Part 21 Report No: P21-04302015, Rev. 2

Subject: **Update** - Report of potential 10CFR Part 21, Allen Bradley Timing Relay Model 700RTC – NRC Event Number 51030, Accession Number ML15134A016

Figure 2 - New design circuit board and CPLD that replaced the original component.

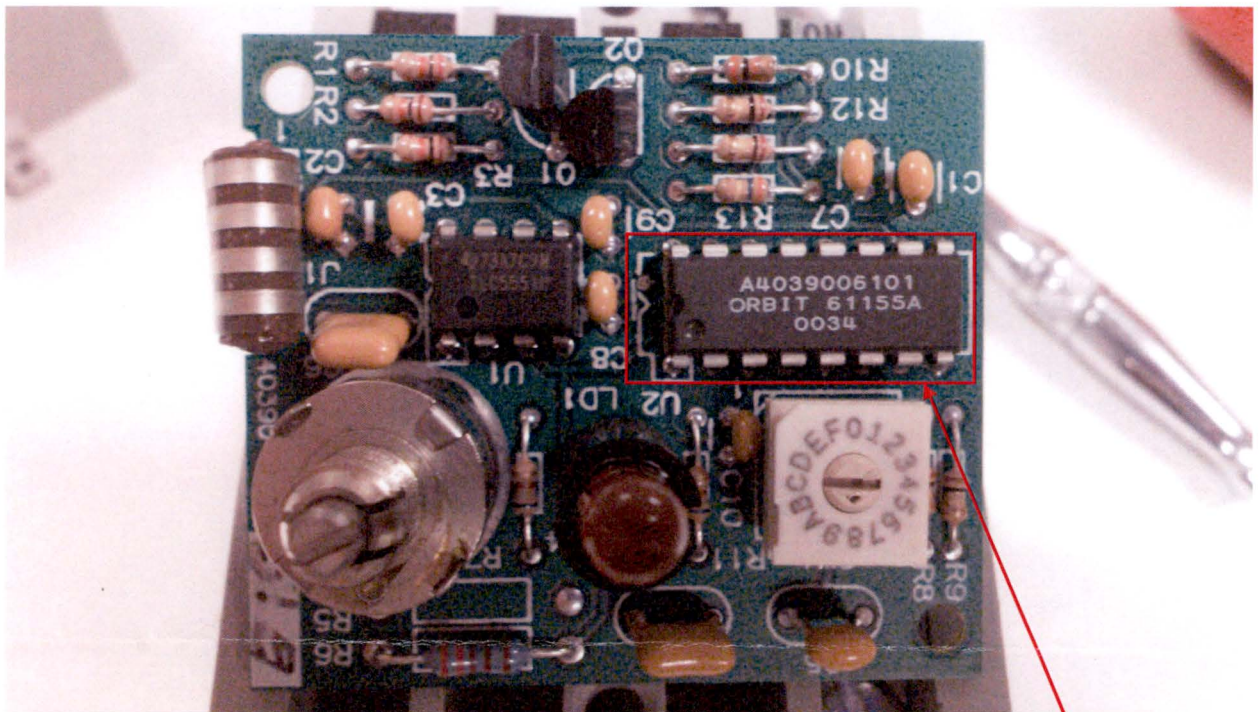
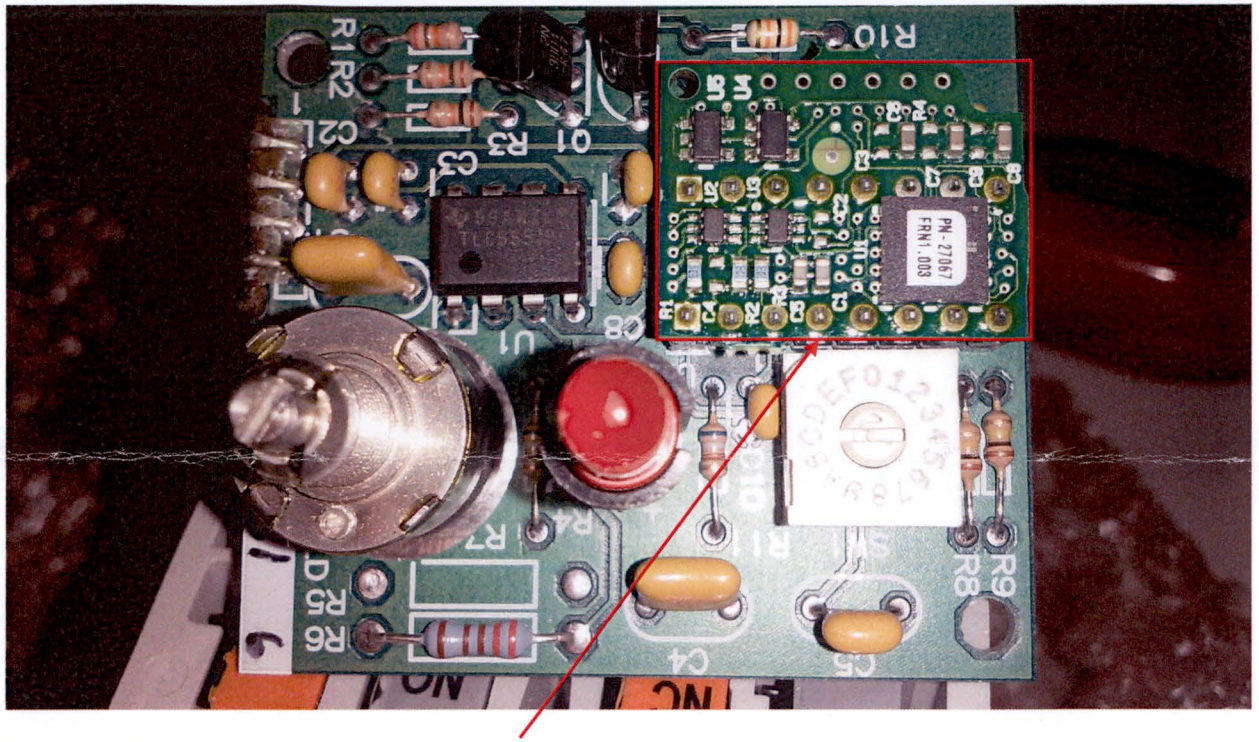
Between 2009-2010, Allen Bradley made a design change without changing the part number of the commercial relay or providing any documented evidence of a design change. The manufacturer specification data sheets maintain the classification that the relays are “solid state”, which would imply that there are no digital devices installed in the relay. However, after inspection of the internals of the timing relay (Figure 2), it has been identified that the unit does contain a CPLD which meets the definition of a digital device under the guidance of NEI 01-01. See Figures 1 and 2 below:

Figure 1- Original qualified design (prior to 2009).
Relays supplied prior to 2009 are not affected by this issue.

The results were satisfactory with exception of the following condition: During Conducted Susceptibility CS114 onto the power lines, with the timing circuit in operation, the instantaneous contacts exhibited chatter in the range of 2.6 MHz to 20.3 MHz. The unit requires a ferrite to be installed onto the input power lines of the relay with 3 turns through the ferrite core. In this modified configuration, the relay was not susceptible to Conducted Susceptibility and successfully passed the required test per CS114.
